BUILDING 'E' AND BUILDING 'F' POWER PLAN

**RUTH HARDING SCHOOL
 MODERNIZATION**
 3201 PICO ST.
 FOR
BAKERSFIELD CITY SCHOOL DISTRICT
 BAKERSFIELD, KERN COUNTY, CALIFORNIA

**BLDG. 'E' & 'F'
 POWER PLAN**

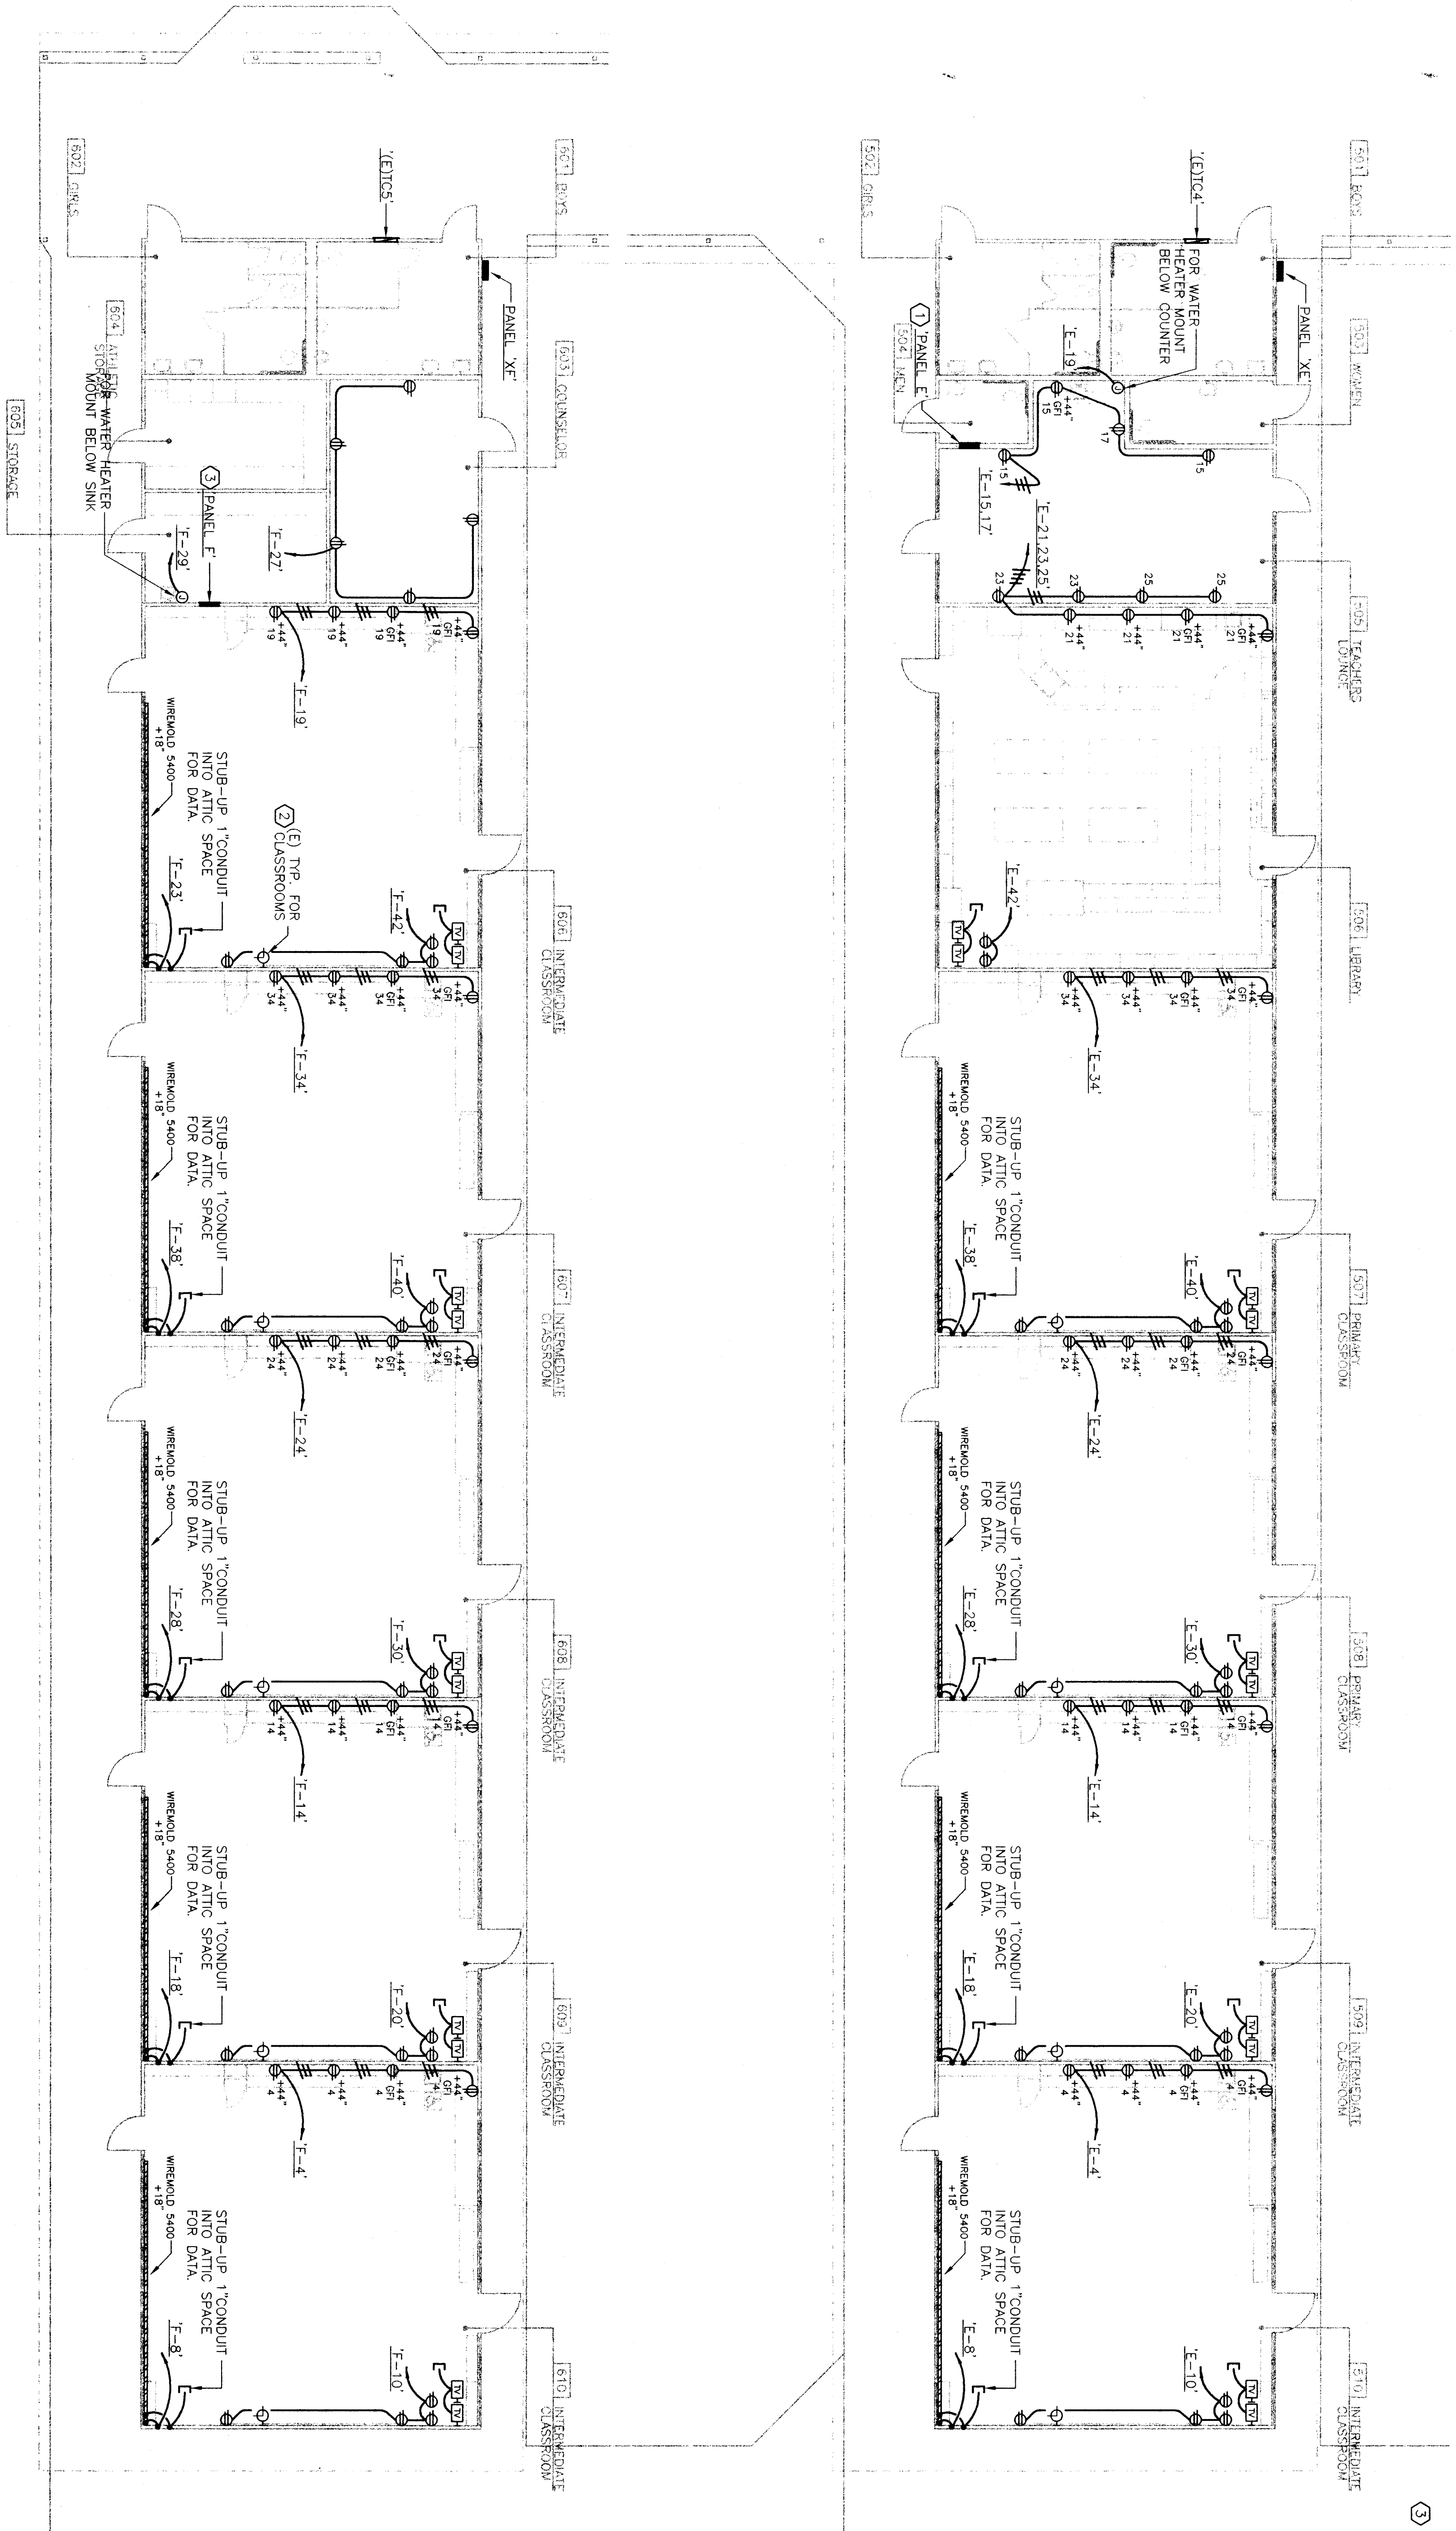
48. Refer to Electrical Drawing E-4.2, Buildings 'E' and 'F' Power Plan. Scope of electrical work has been reduced. Refer to revised Electrical Drawing E-4.2, as attached to this addendum.
